# **CTA Standard**

**Audio Format Extensions**

**CTA-861.5**

#### **Audio Format Extensions**

Figure 1 Speaker Placement

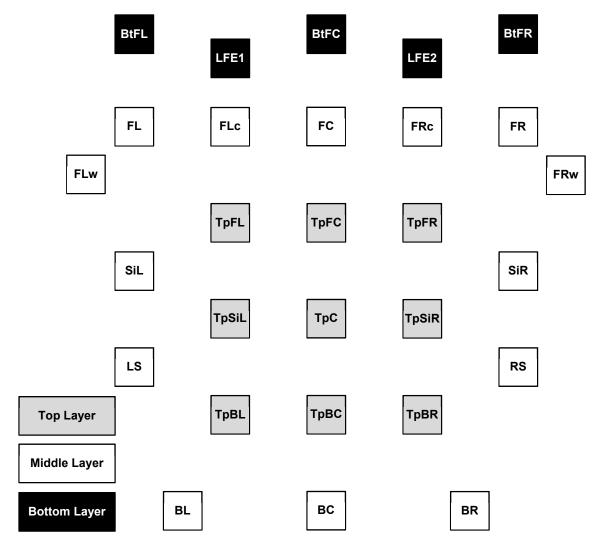
Figure 1 shown below, replaces Figure 6 in section 6.6.2 of CTA-861-G:
